CITY OF SUPERIOR, WISCONSIN
 DEPARTMENT OF PUBLIC WORKS

CONTRACT NO. 3
 LIFT STATION & STORAGE IMPROVEMENTS

LIFT STATION #6, COLLECTION SYSTEM
 AND STORAGE IMPROVEMENTS
 LOCATION MAP AND DRAWING INDEX

LIGHT POLE

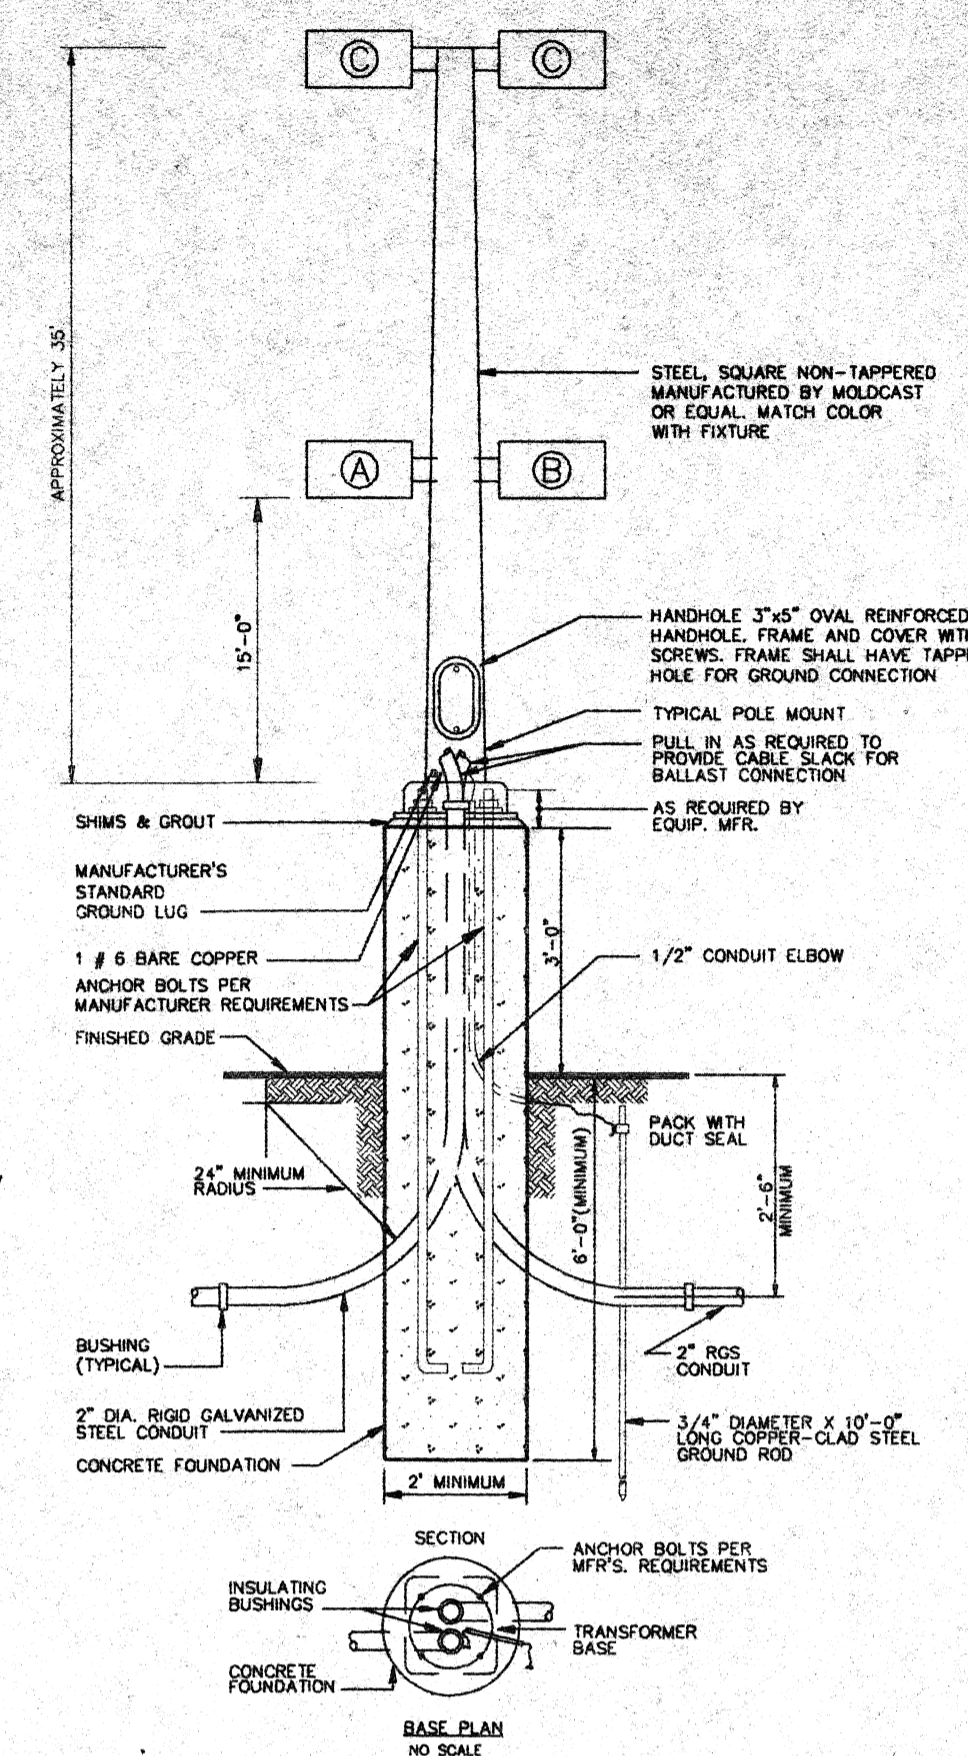
Add following to light pole drawing:

- 120 V, 20 Amp, GFCI, weatherproof duplex receptacle to be provided at base of all light poles. Receptacles to be switched at control panel.
- Switches to control yard lighting to be housed in control panel.

Sheet G-7:

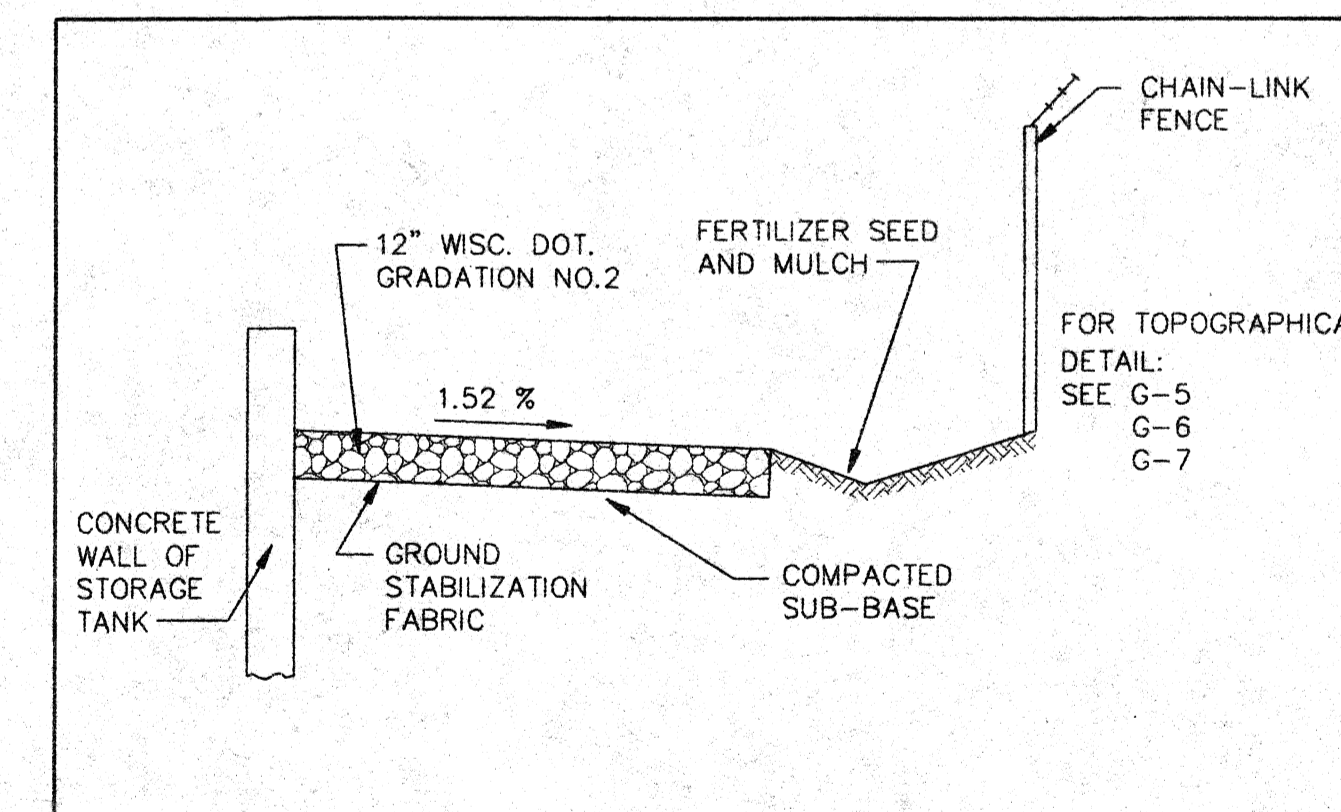
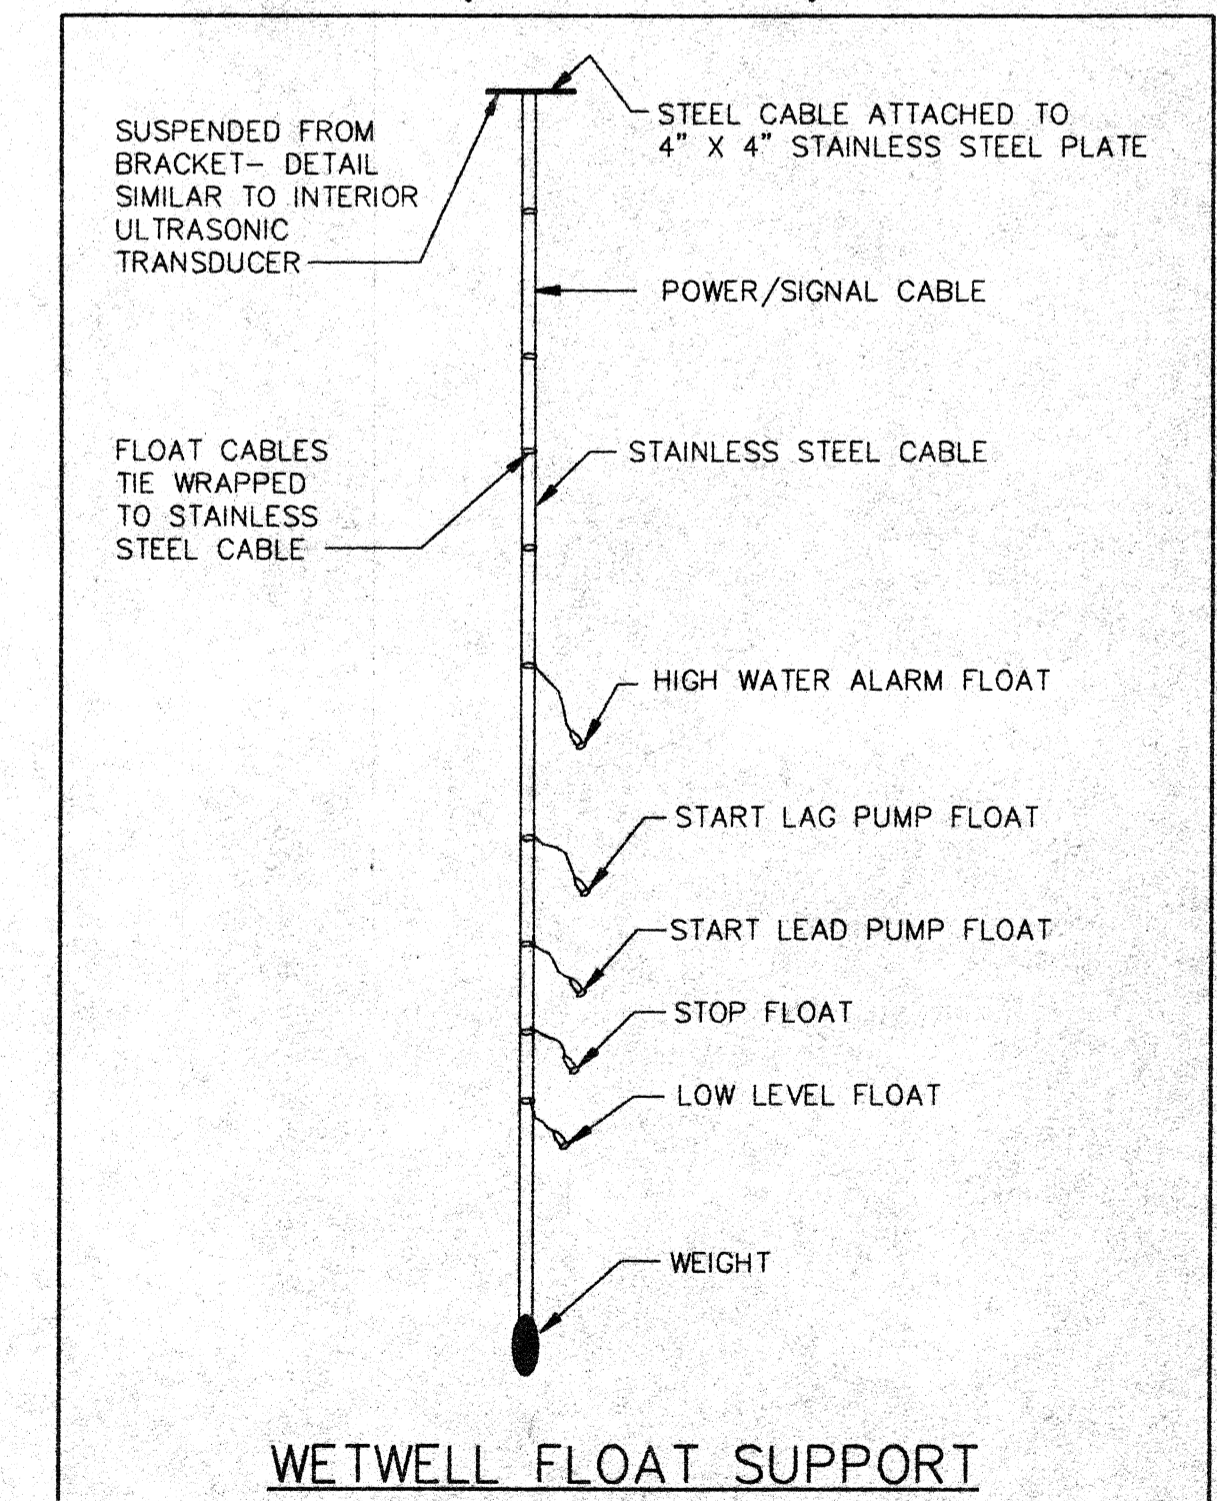
- Remove davit crane drawing and information (see revised crane in Item 6 of Specifications above).
- Rename Ultrasonic Level Meter Drawing as Level Meters and modify Section A-A with the following:

- Ultrasonic Level Meter Transducer Bracket/Assembly Notes:**
- All hardware and brackets to be stainless steel.
 - 1/4" lip to be provided on bracket.

- Float Tree Bracket/Assembly Notes:**
- Float tree cable to be stainless steel and attached to 1/4" stainless steel plate for placement on bracket.
 - All hardware and brackets to be stainless steel.
 - 1/4" lip to be provided on bracket.
 - Stainless steel handle for lifting of float system to be provided.
3. Add following to meter manhole drawing:
